APPENDIX 6

Comments and Responses on Proposed 2016 Monitoring Network Plan, Revision 0

COMMENTS AND RESPONSES ON
PROPOSED 2016 MONITORING NETWORK PLAN, REVISION 0

The public comment period for the proposed 2016 Missouri Monitoring Network Plan opened on May 27, 2016 and closed on June 28, 2016. The Missouri Department of Natural Resources' Air Pollution Control Program prepared the 2016 Monitoring Network Plan to address the requirements of 40 CFR 58.10 (a) (1) for annual submittal of a plan to provide information on current State or Local Air Monitoring Stations (SLAMS), other ambient air monitoring, and any proposed network changes for the upcoming year.

Figure 1. Receptors with modeled design values ≥ 75 percent of the maximum design value.

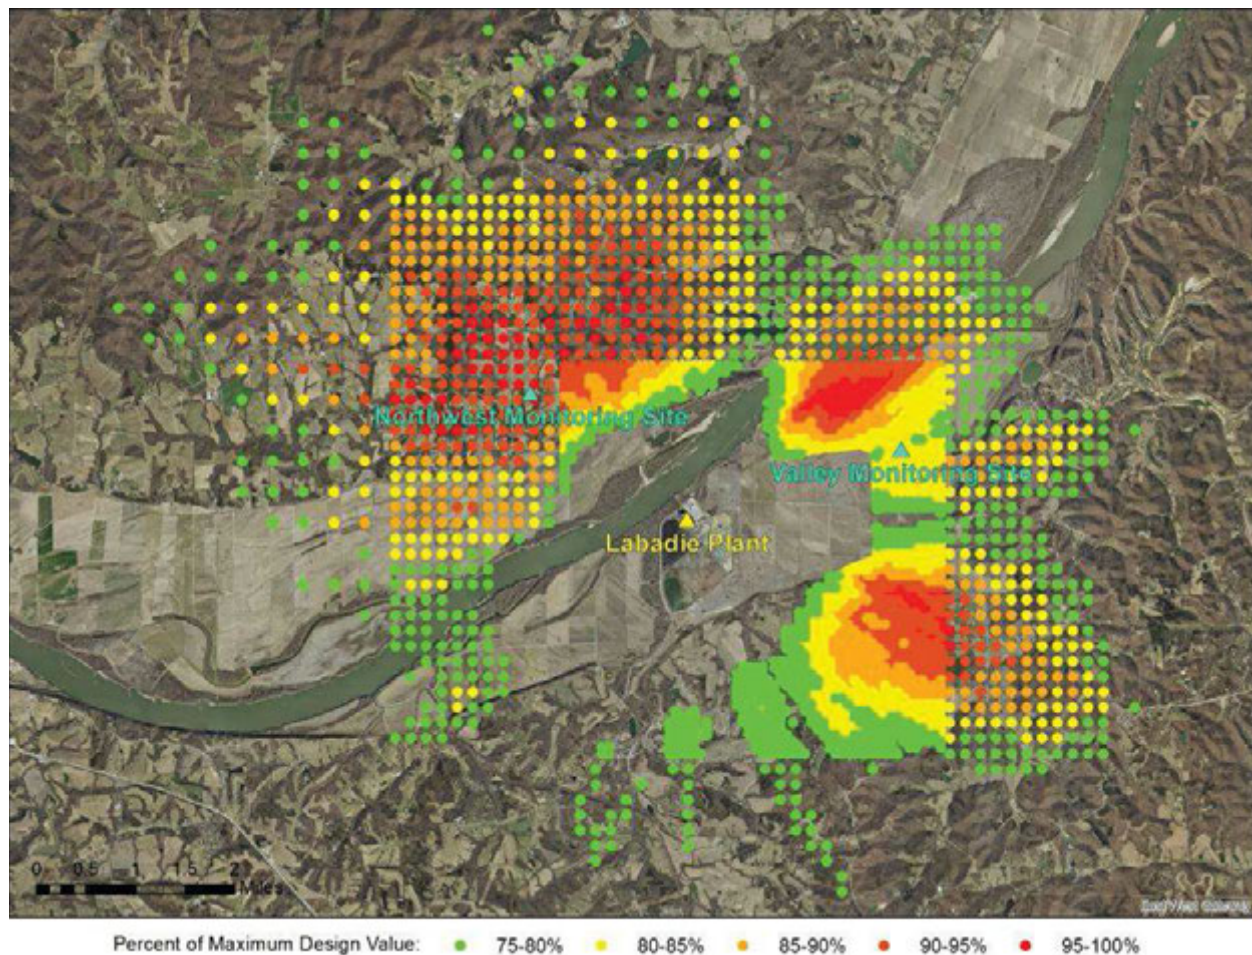
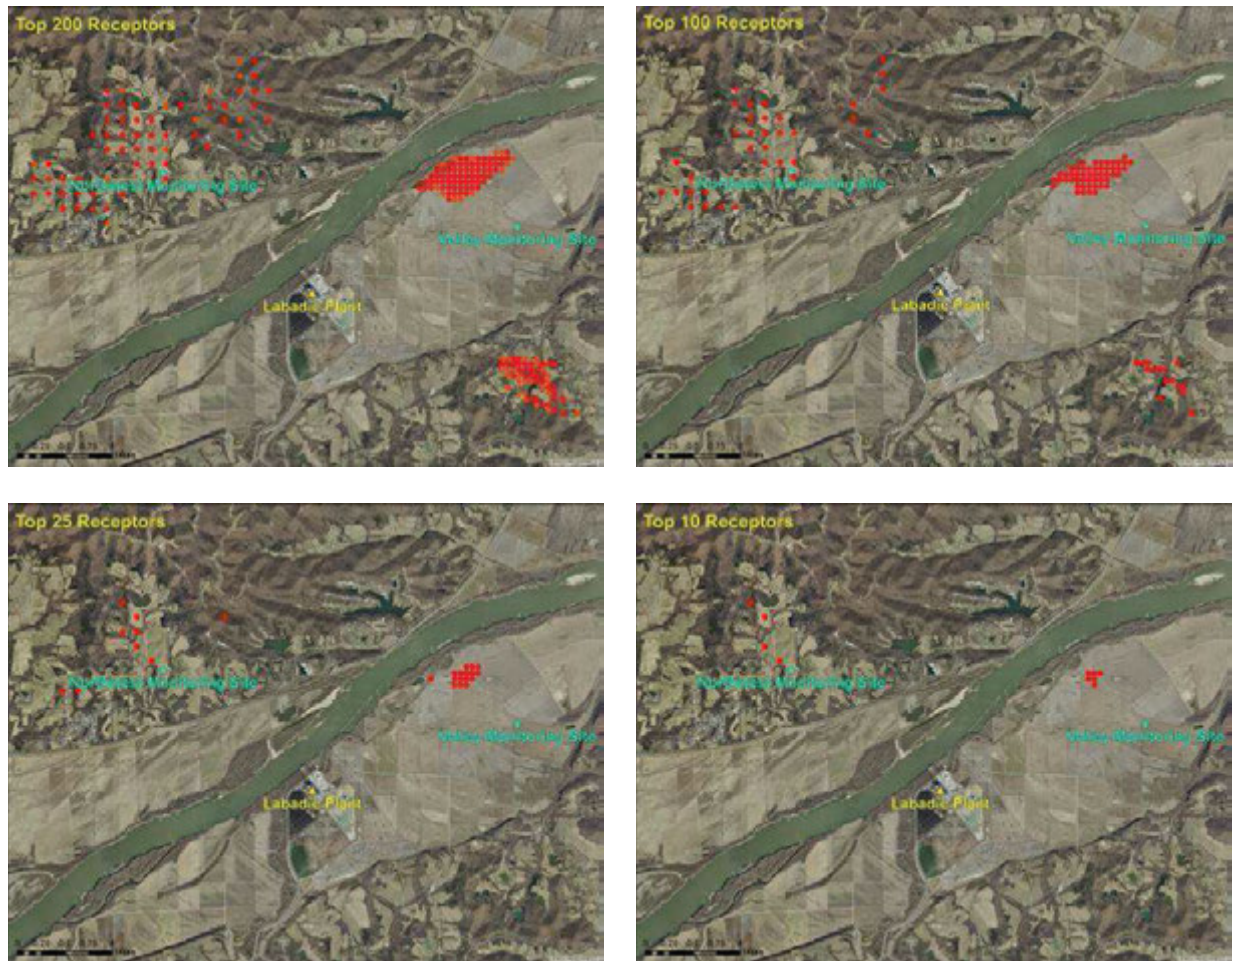
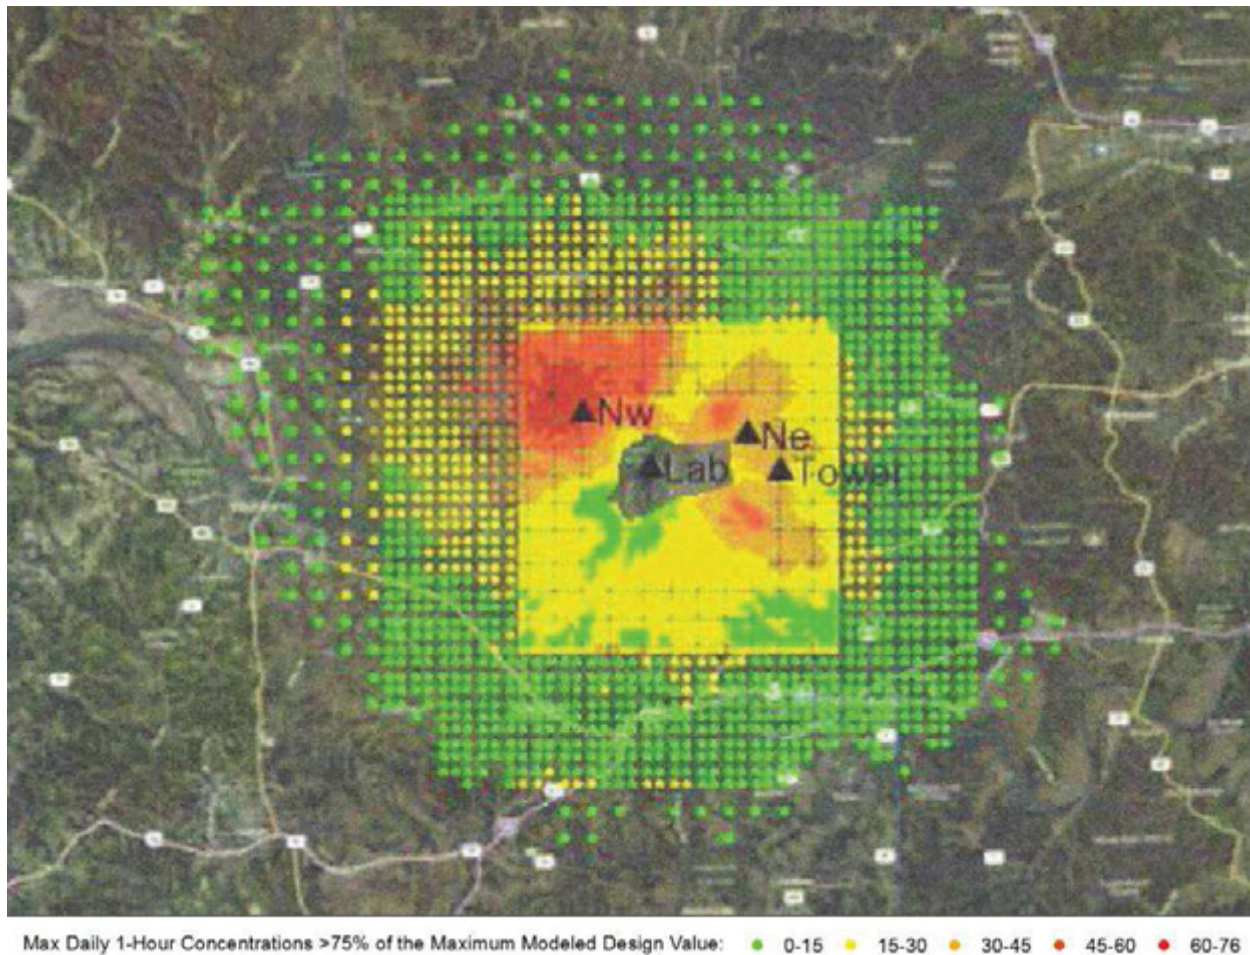
Appendix 10 of the QAPP describes the modeling performed to determine the locations of the proposed ambient SO₂ monitoring stations around the Labadie Energy Center. The modeling was used to determine locations where peak 1-hour SO₂ concentrations are expected to occur due to the plant's SO₂ emissions given that the primary objective of source-oriented monitoring is to identify peak SO₂ concentrations in ambient air that are attributable to an identified emission source or group of sources.¹ Figure 1 shows all receptors with modeled design values greater than or equal to 75 percent of the maximum modeled design value. Figure 2 shows the receptors with the top 200, 100, 25, and 10 modeled design values.

Figures 1 and 2 reveal three distinct areas where modeled design values are in excess of 95 percent of the maximum modeled design value and where the majority of the top 200 receptors (and all of the top 100, 25 and 10 receptors) lie. These areas, located northwest, northeast, and southeast of the Labadie Energy Center, are where the modeling predicts peak 1-hour SO₂ concentrations are expected to occur. Furthermore, although a rigorous comparison is not possible without detailed receptor data, a simple visual comparison of Figures 1 and 3 indicates that the areas where peak 1-hour SO₂ concentrations are expected to occur (i.e., where modeled design values are in excess of 95 percent of the maximum modeled design value) overlap with the areas where daily maximum 1-hour SO₂ concentrations most frequently exceed 75 percent of the maximum modeled design value. Monitoring stations located in these areas would have the greatest chance of identifying peak SO₂ concentrations in ambient air, which is the primary objective of source-oriented monitoring and an absolute necessity when monitoring to assess compliance with the NAAQS.

However, only one of Ameren's proposed monitoring sites, the northwest site, is located in one of the three peak concentration/high frequency areas predicted by the modeling (the one located northwest of the plant). No monitoring sites are proposed in the peak concentration/high frequency areas located northeast or southeast of the plant. Instead, Ameren's only other proposed monitoring site, the valley site, is located in an area where modeled design values are only about 80 percent of the maximum modeled design value and where daily maximum 1-hour SO₂ concentrations exceed 75 percent of the maximum modeled design value about half as often as they do in areas where this occurs with the greatest frequency. This makes the valley site an inappropriate site for a monitor to assess compliance with the NAAQS. Ameren's modeling predicts that ambient SO₂ concentrations will be as much as 25 percent higher in several areas around the plant than they will be at the valley site, meaning a monitoring station at the valley site could be in compliance with the NAAQS while significant violations were occurring nearby.

Figure 5. Ameren's proposed SO₂ monitoring sites relative to DNR's polygons. Peak concentration areas (>90 ug/m³) are shaded red.

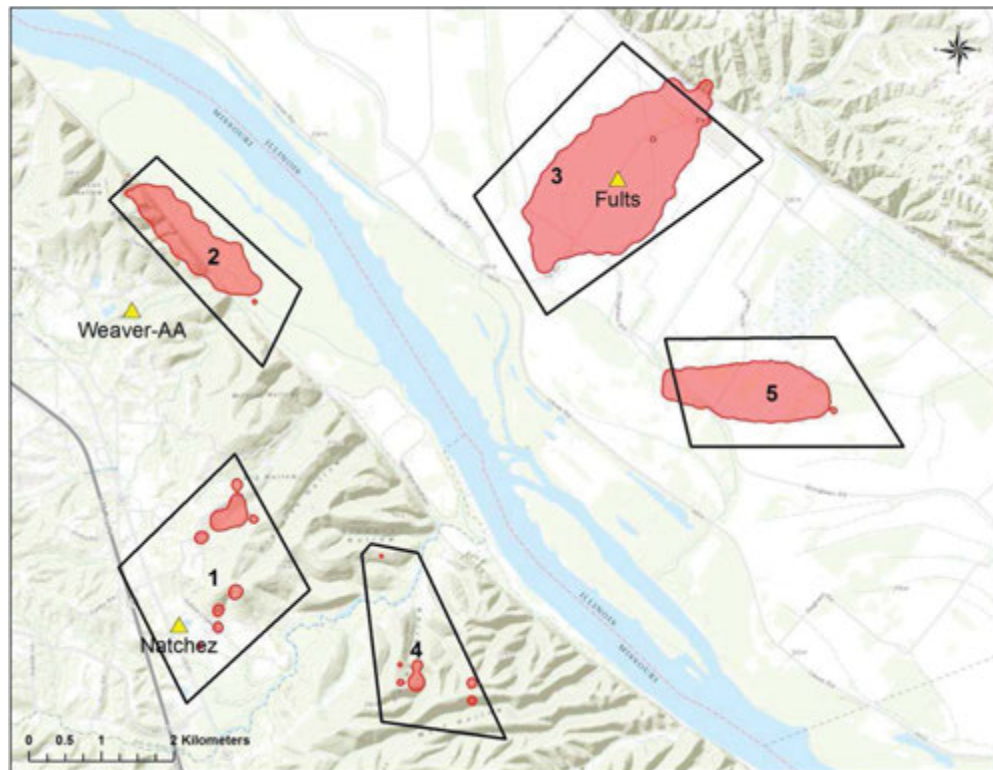
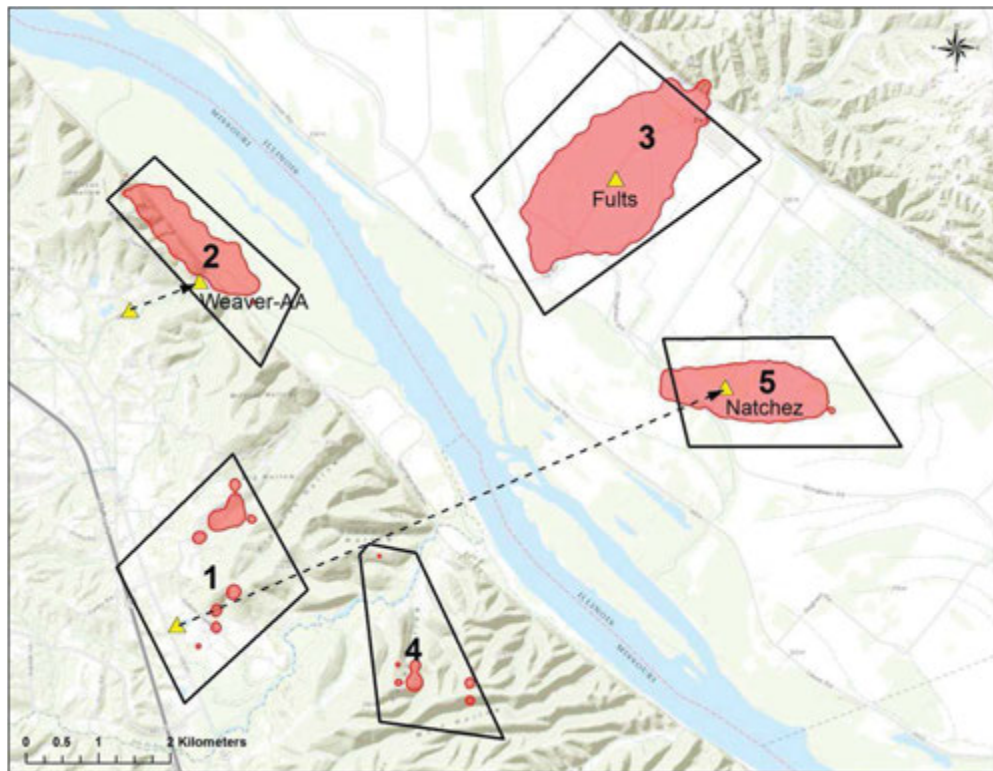
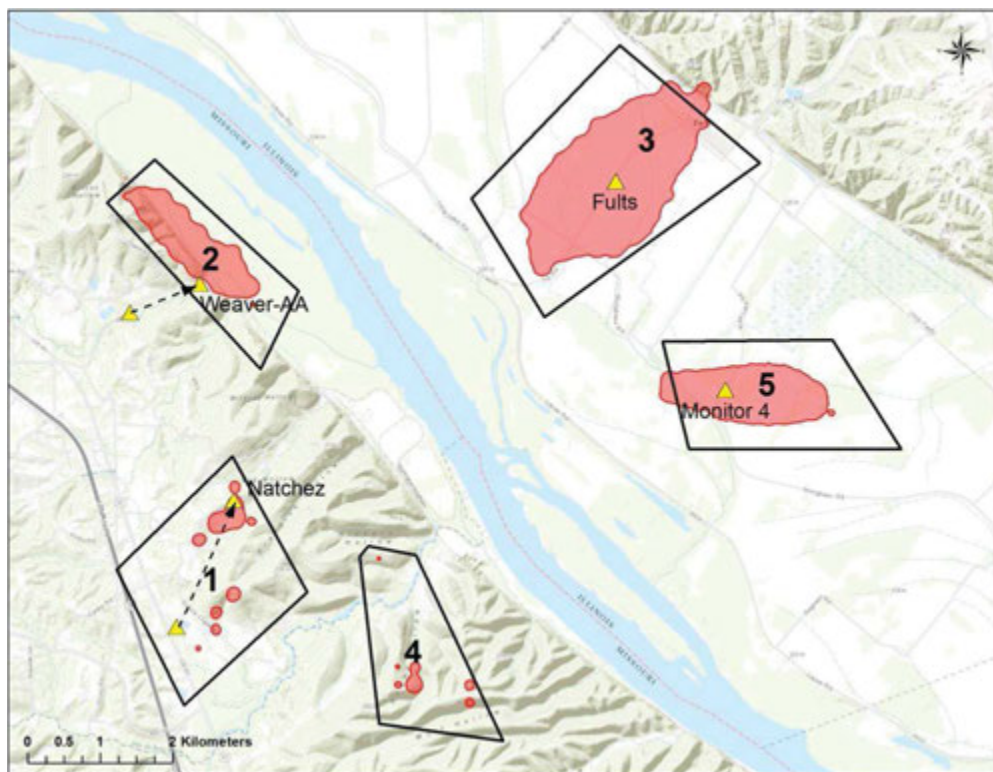
The locations of Ameren's proposed SO₂ monitoring sites – dubbed Fults, Natchez and Weaver-AA – relative to DNR's polygons are shown in Figure 5 below. Of the three proposed sites, only the Fults site, which is inside the peak concentration area within polygon 3, is properly located. The Weaver-AA site, which Figure 2 of Monitoring Network Plan Appendix 5 incorrectly shows being within polygon 2, is actually located outside of it based on the site coordinates provided in Plan Appendix 1. Hence it is not properly located. Nor is the Natchez site, which should be located within polygon 5 instead of polygon 1 because polygon 5 has higher modeled impacts.

Because they are not properly located, neither the Natchez nor Weaver-AA monitoring sites will adequately represent Rush Island's SO₂ air quality impact. Therefore, both sites should be relocated. The Weaver-AA site should be located inside the peak concentration area within polygon 2 and the Natchez site should be located inside the peak concentration area within polygon 5 as shown in Figure 6 below. Alternatively, the Natchez site could be moved inside the peak concentration area within polygon 1 and a fourth monitor added inside the peak concentration area within polygon 5 as shown in Figure 7 below. The recommended monitor locations shown in Figures 6 and 7 are easily accessible and appear to meet EPA siting criteria and have ready access to power.

Figure 2. Expected peak SO₂ concentration areas per DNR's modeling.

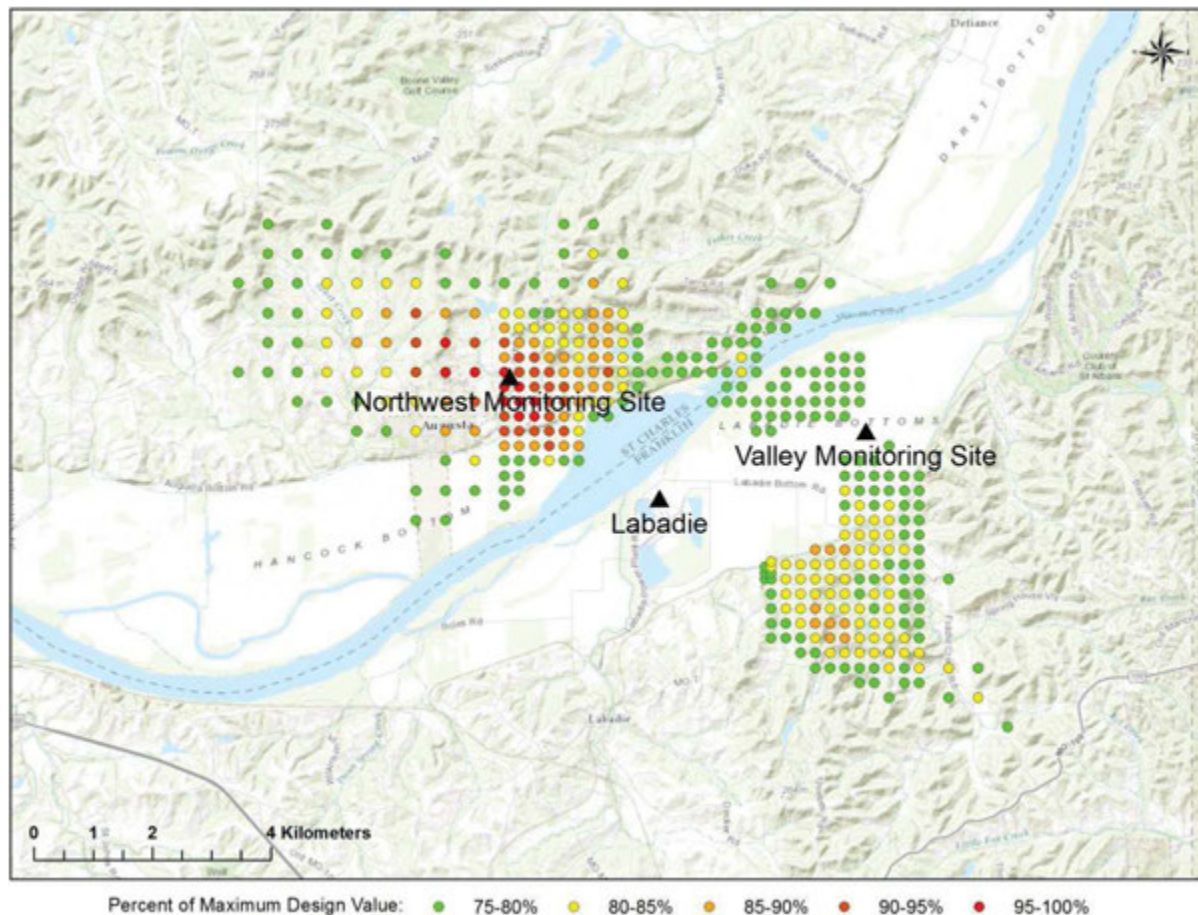
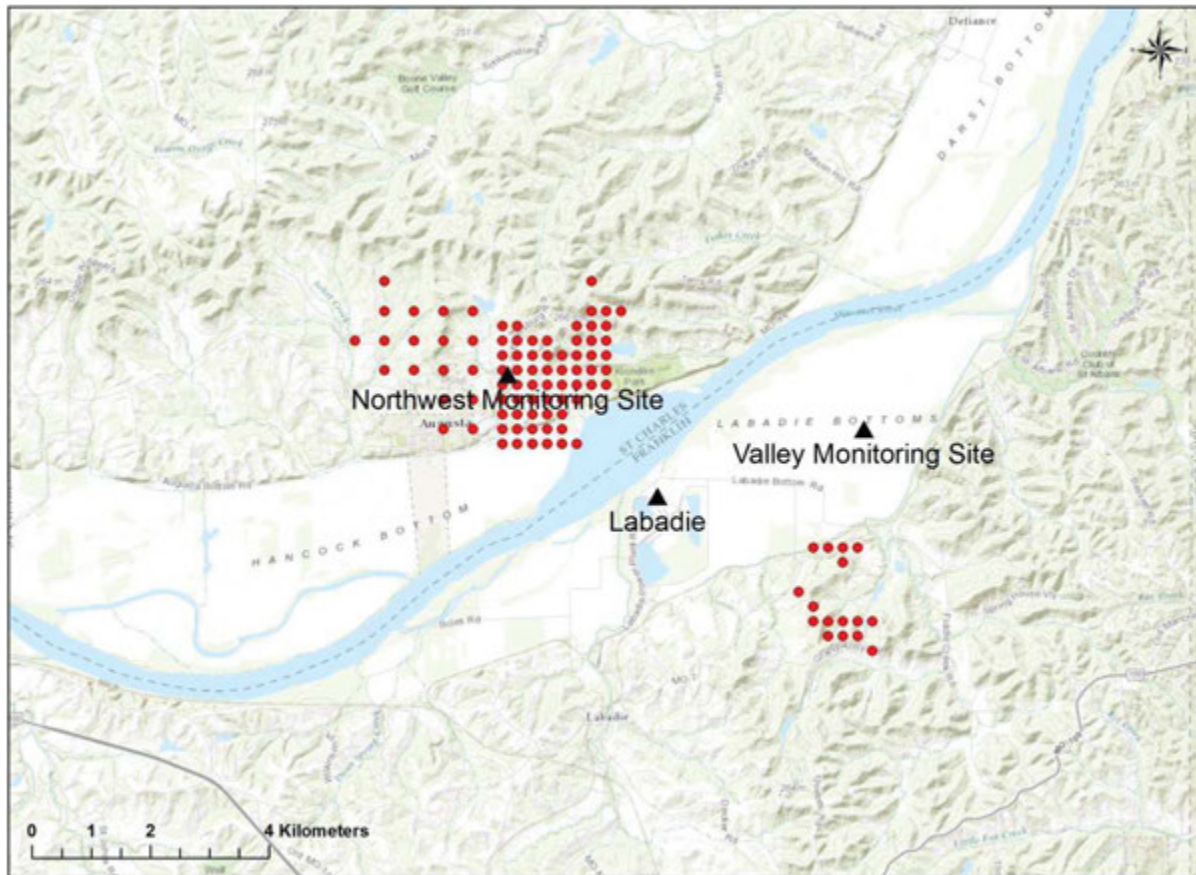
DNR's modeling, as illustrated by Figures 2 and 3, confirms that the Valley monitoring site is not located in an area where peak SO₂ concentrations are expected to occur. To the contrary, the Valley site is in an area where the modeled concentration is less than 75 percent of the maximum concentration predicted by DNR's model. DNR's modeling also confirms that there is an expected peak concentration area southeast of the plant with considerably higher modeled SO₂ design values than at the Valley monitoring site, yet with no monitor. DNR's model predicts NAAQS exceedances in this other area, but not at the Valley site.

Figure 4. Valley monitoring site (left) and KSUS (right) wind rose comparison.

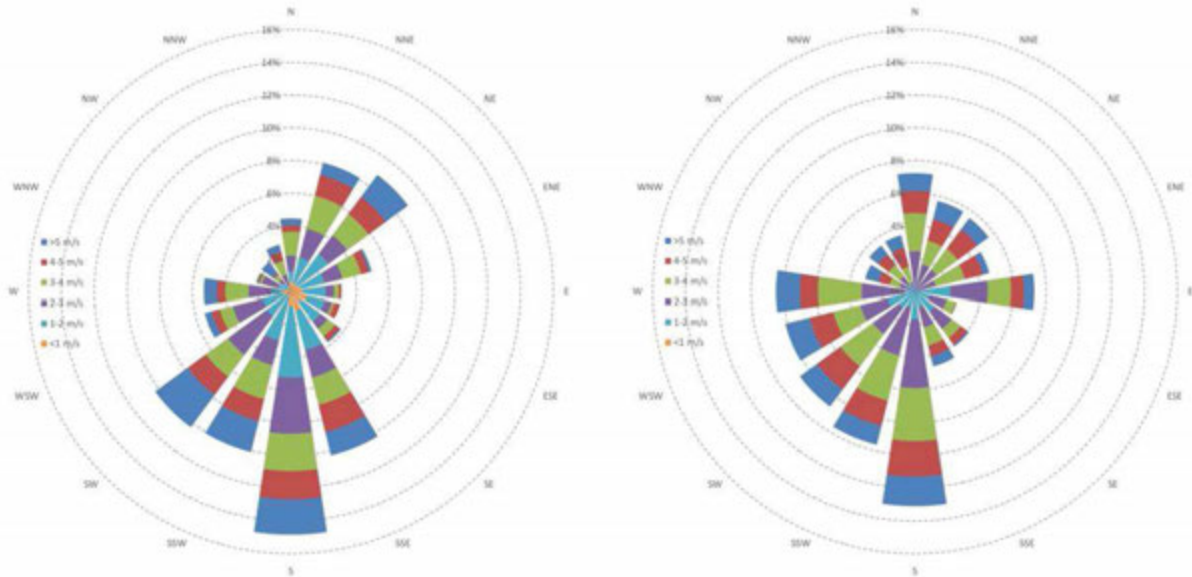
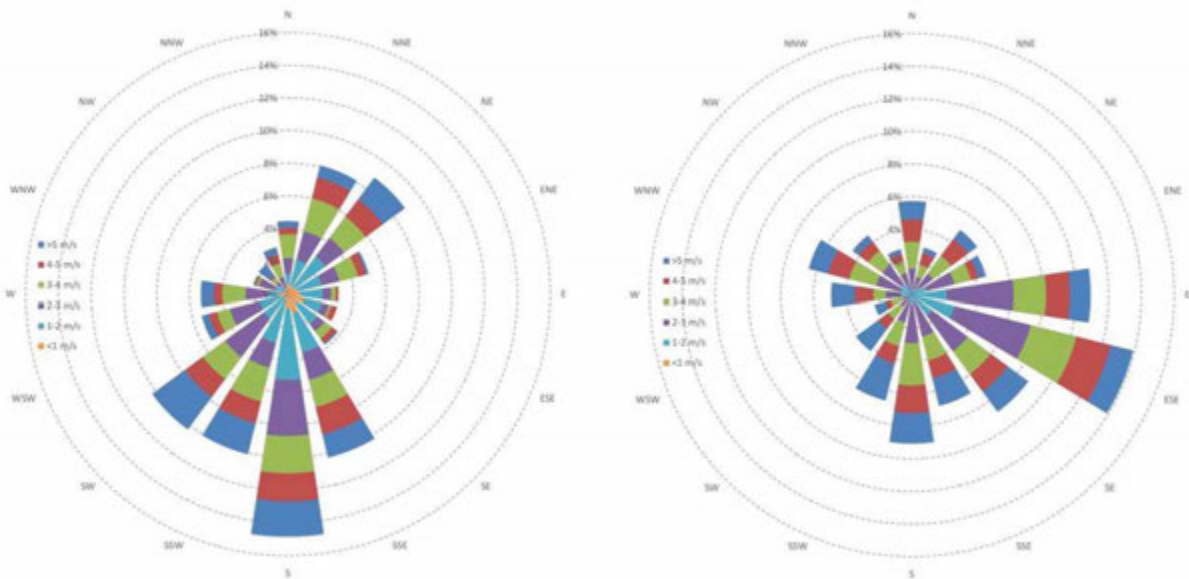
Figures 4 and 5 (see next page) show the wind rose for the Valley monitoring site compared to the wind roses for KSUS and KJEF, respectively, for the period April 22 – July 13, 2015. As illustrated by Figures 4 and 5, during the first few months the Valley meteorological monitoring station was in operation, the most frequent winds at both Labadie and KSUS were from the south, south-southwest, and southwest, whereas the most frequent winds at KJEF were from the east and east-southeast. Furthermore, the strongest winds at both Labadie and KSUS were generally from the predominant wind directions whereas the strongest winds at KJEF were from the south and south-southwest, orthogonal to the predominant wind directions.
